**RGI PROJECT No. 2012-107L
VCP PROJECT No. NW2811**

**SUPPLEMENTAL REMEDIAL INVESTIGATION WORK PLAN
MAIN STREET APARTMENTS DEVELOPMENT
10505 MAIN STREET
BELLEVUE, WASHINGTON 98004**

AUGUST 11, 2016

Subject: **Response to Ecology June 6, 2016 Opinion Letter**
Alamo Manhattan Main Street
10505 Main Street
Bellevue, Washington
Ecology VCP No. NW2811

Main Street Bellevue		Figure 1
RGI Project Number 2012-107L	Proposed Cross Section B - B' Location	Date Drawn: 08/2016
Address: 10505 Main Street, Bellevue, Washington 98004

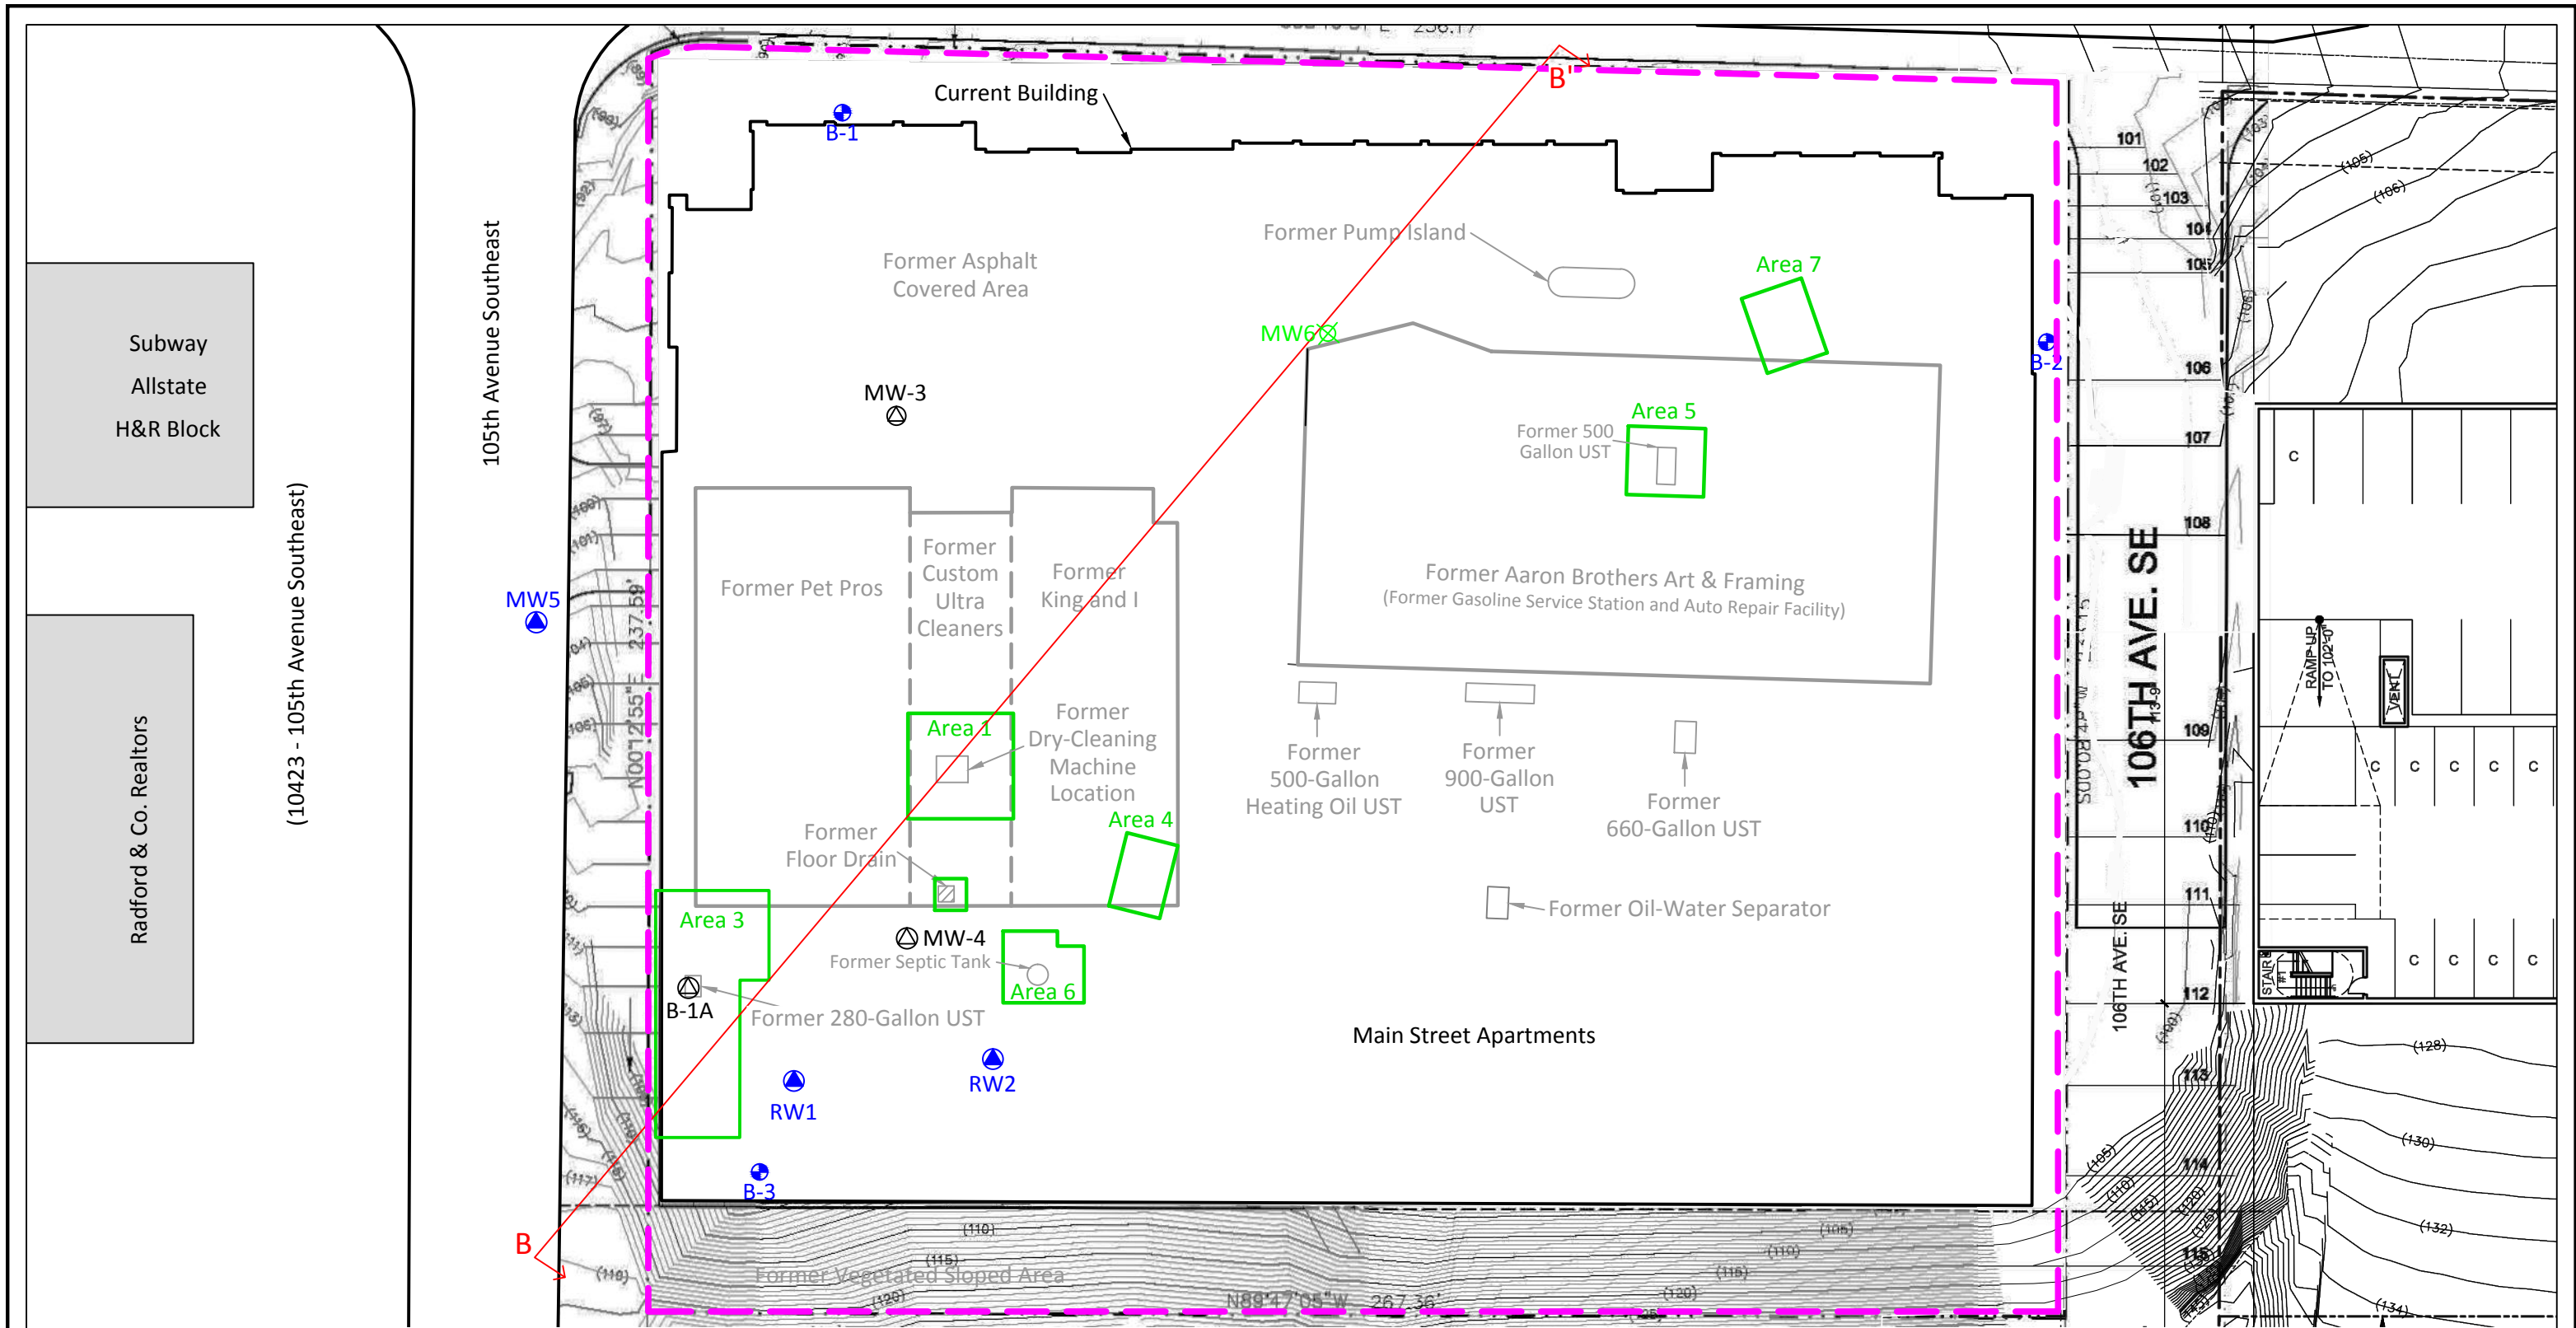
RGI will prepare an east-west cross section (B-B') across the entire Property in the location displayed on the attached Figure 1. Ecology has indicated that this is an acceptable location for the cross section, which will display the current building layout relative to former features on the Property. The cross section will also display locations where soil contamination remains in place on the Property with select analytical data and include groundwater elevation data as well.

As discussed with Ecology, the cross section will display pertinent current and historical features situated within 20 feet offset from the cross section.

Main Street Bellevue		Figure 2
RGI Project Number 2012-107L	Garage Layout with Proposed Groundwater Monitoring Well Location	Date Drawn: 08/2016
Address: 10505 Main Street, Bellevue, Washington 98004

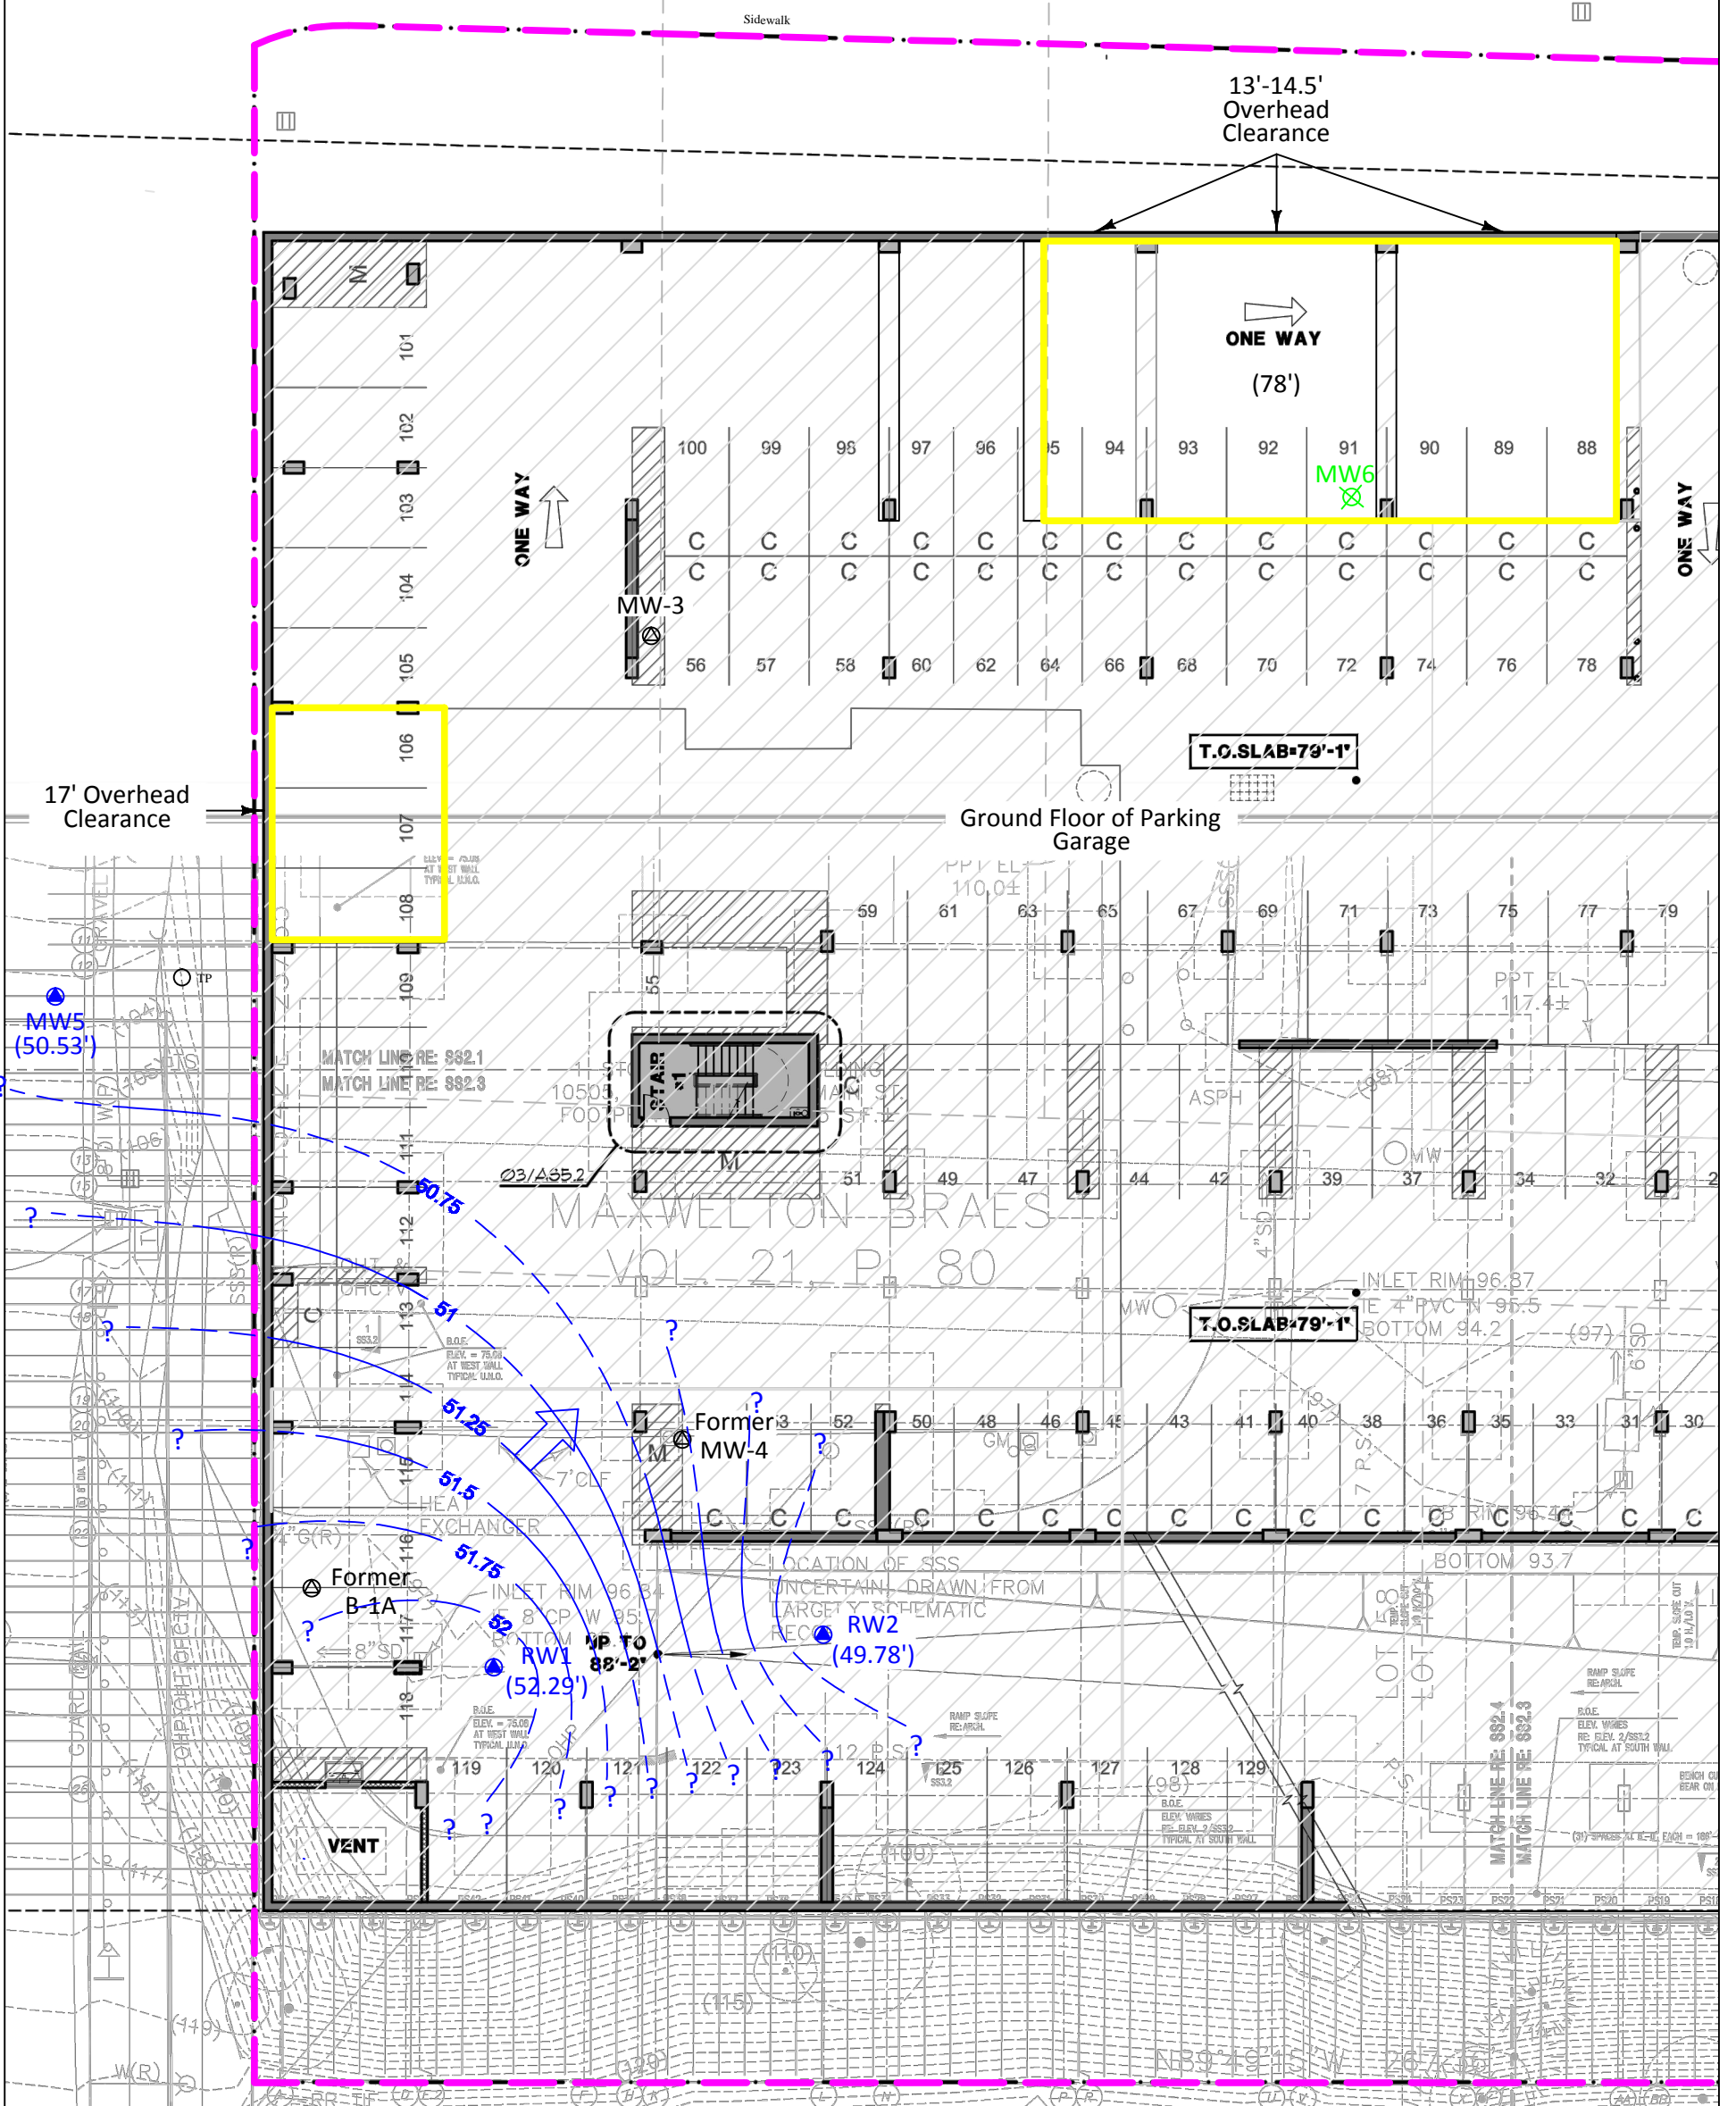
Ecology has requested that a groundwater monitoring well be installed down-gradient of existing wells RW1 and RW2 and former wells B-1A and MW-4, where concentrations of benzene and diesel-range TPH were previously detected above MTCA Method A Cleanup Levels for Groundwater. The locations of the proposed well, existing wells, and former wells are depicted on Figures 1 and 2.

As discussed with Ecology, RGI assessed the underground parking garage for drilling access and determined two locations (represented by the highlighted boxes on Figure 2) where drilling is possible due to sufficient overhead clearance in these areas. Drilling outside of these locations is not possible due to limited overhead clearance. Therefore, Ecology and RGI agree that the most appropriate accessible location for MW6 is the location proposed on Figure 2. The scope of work required to install this well is discussed in this section.

Proposed groundwater monitoring well MW6 will be installed in the location depicted on Figures 1 and 2. This well be constructed and screened similar to the other wells associated with the Property.

RGI and Alamo Manhattan Response: This comment is addressed by the installation and sampling of groundwater monitoring well MW6, which will be situated downgradient of these locations. Ecology has indicated that the proposed location of MW6 is acceptable. Details pertaining to proposed installation of well MW6 are described in Section 3.3 of the Work Plan.
